Product Instructions

NOTICE:

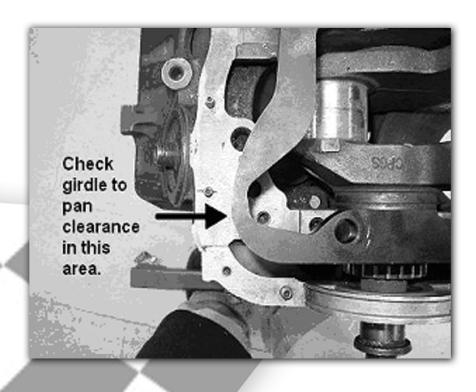
When using oil pan #13-672SV with #21-062 Main Support, minor clearancing may be required for proper fitment of the oil pan. This can be accomplished by lightly grinding the edge of the girdle in the area shown above.
